Terex Utilities**PRODUCT ADVISORY****PA698****DATE: 6/22/2021****REVISED:****TO: Owners, Users, Dealers, and Installers****MODELS AFFECTED: C4000, C5000, C6000, & General Digger Derricks****SUBJECT: Digger Derrick ANSI Standard Decal****Issue:**

Figure 3. Digger Derrick Decal

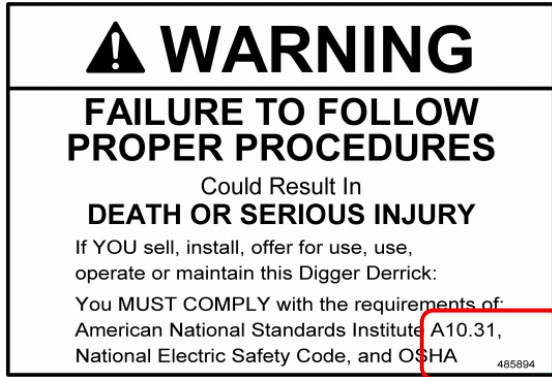
Terex digger derricks may have the incorrect ANSI compliance decal installed. The incorrect decal states that operators must comply with the requirements of American National Standard Institute A92.2 whereas the correct decal references American National Standard Institute A10.31.

Inform all users and service personnel that the incorrect decal may be installed on their machine, which will refer them to the incorrect ANSI standard. The correct standard for a digger derrick is ANSI A10.31. The decal will be located near the control station as shown in Figures 1 and 2.

The decal for digger derricks is part number 485894, as shown in Figure 3. The decal for aerial devices is part number 468476A, as shown in Figure 4.

Terex is making available the correct decal at no cost to the owner for 90 days after the release date of this bulletin. After the 90 days, the decal, part number 485894, will be available for purchase through Terex replacement parts. Each machine requires one (1) decal.
